[11] **Patent Number: Des. 417,632**

[54] **MASONRY FIXTURES**

UNITED STATES PATENT AND TRADEMARK OFFICE
CERTIFICATE OF CORRECTION

PATENT : Des. 417,632

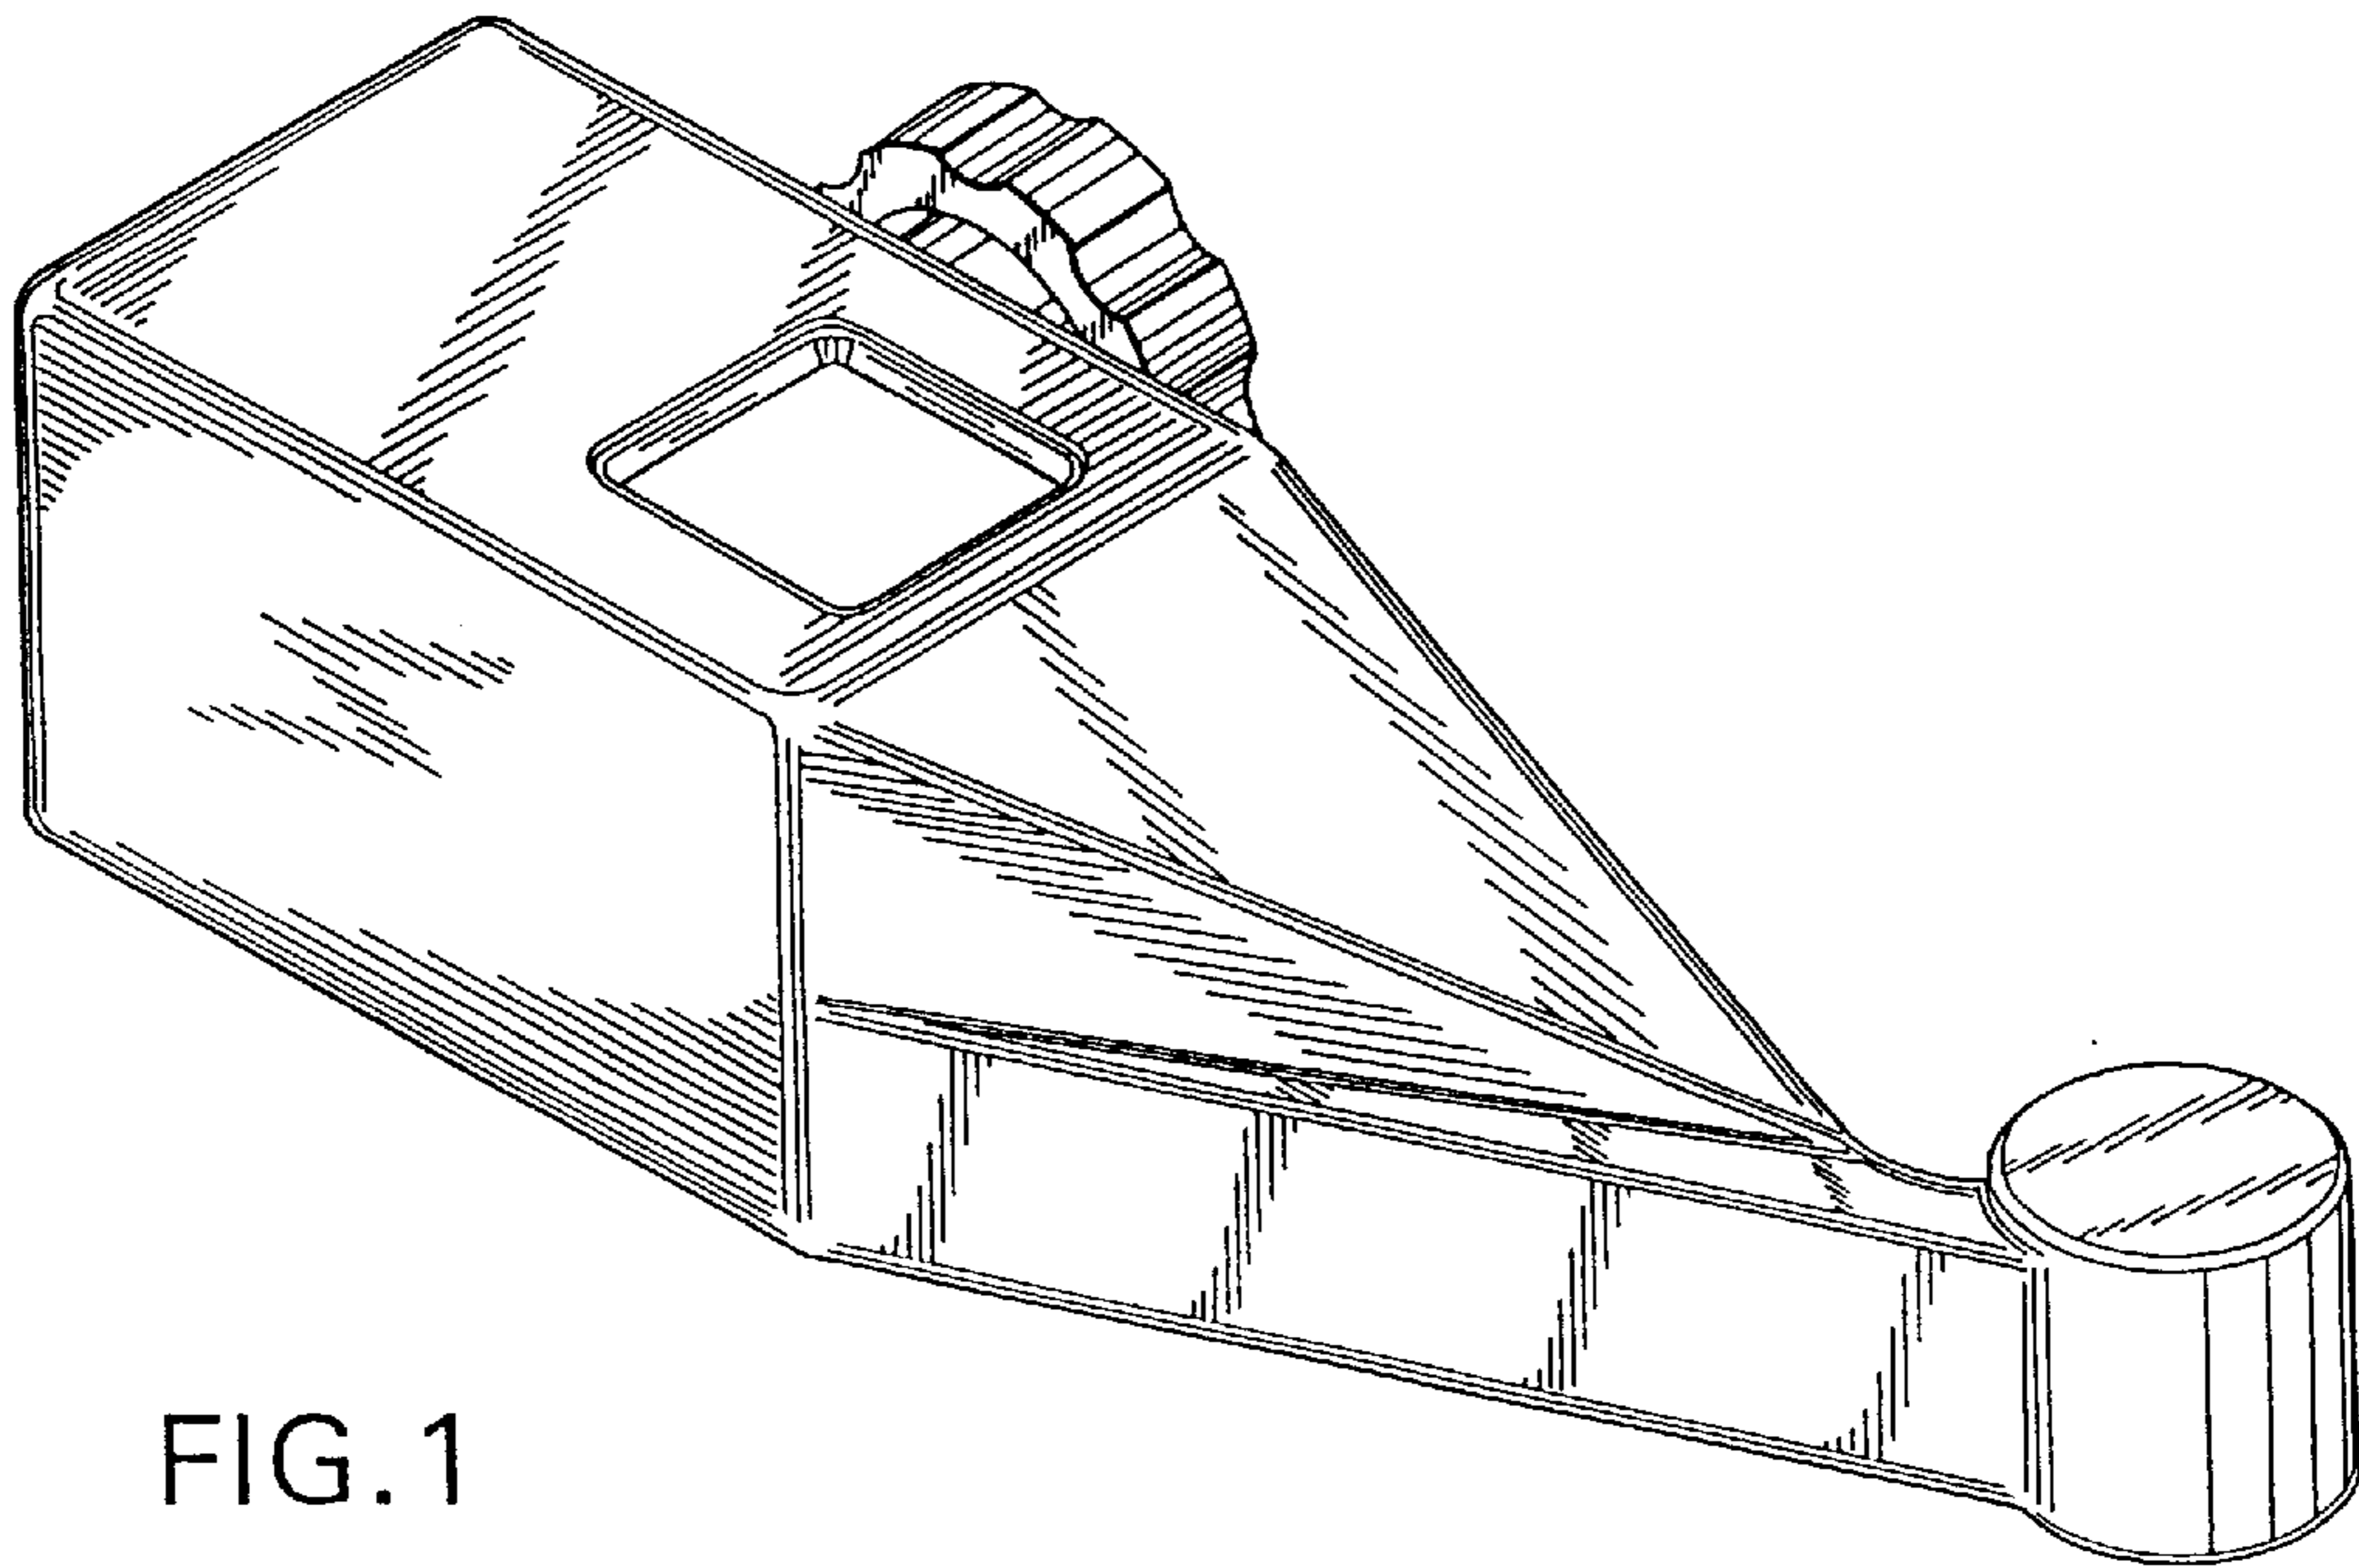
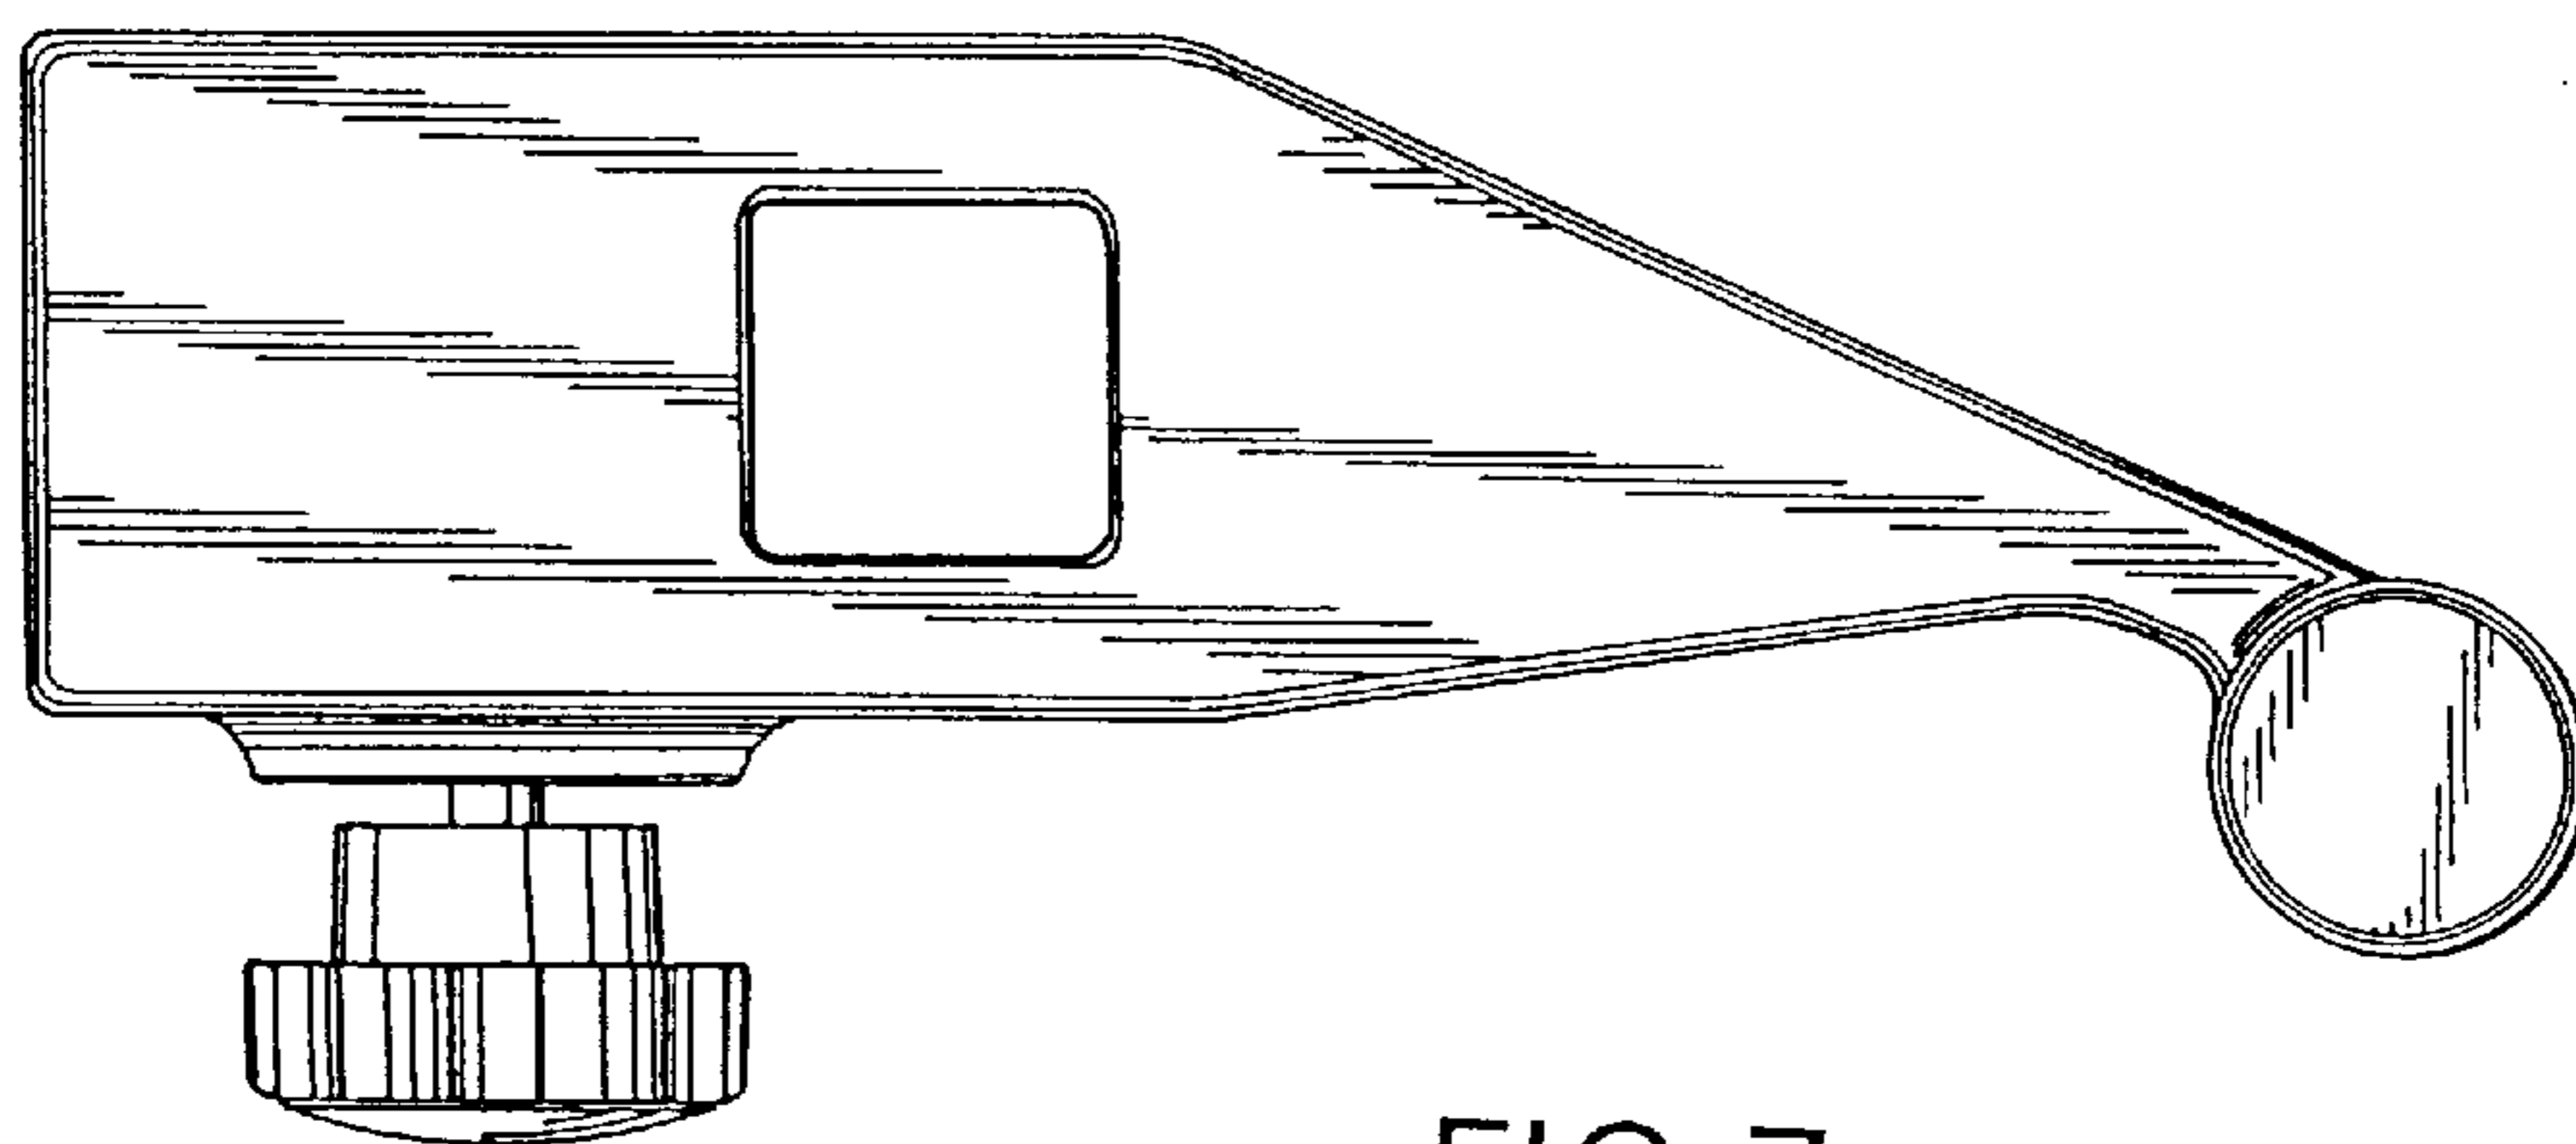
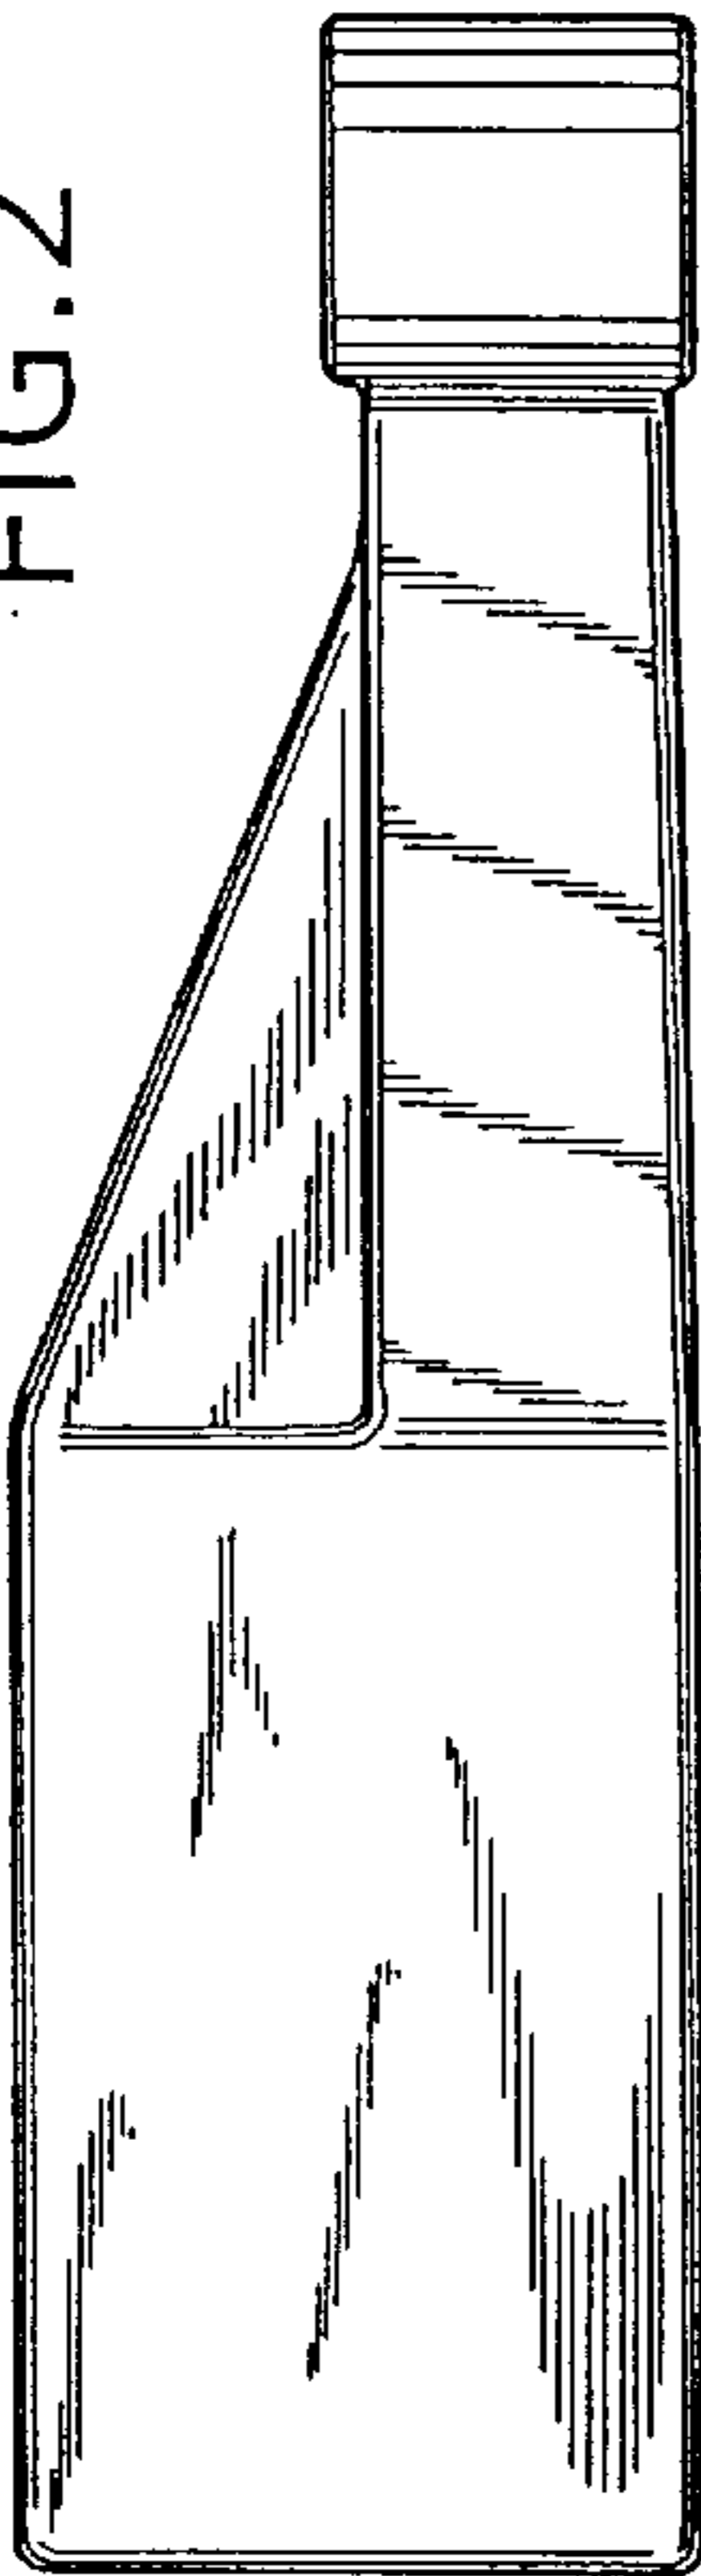
In the drawings, sheets 1 and 2, consisting of Figs. 1-7 should be deleted to be replaced with sheets 1 and 2, consisting of Figs. 1-7, as shown on the attached pages.
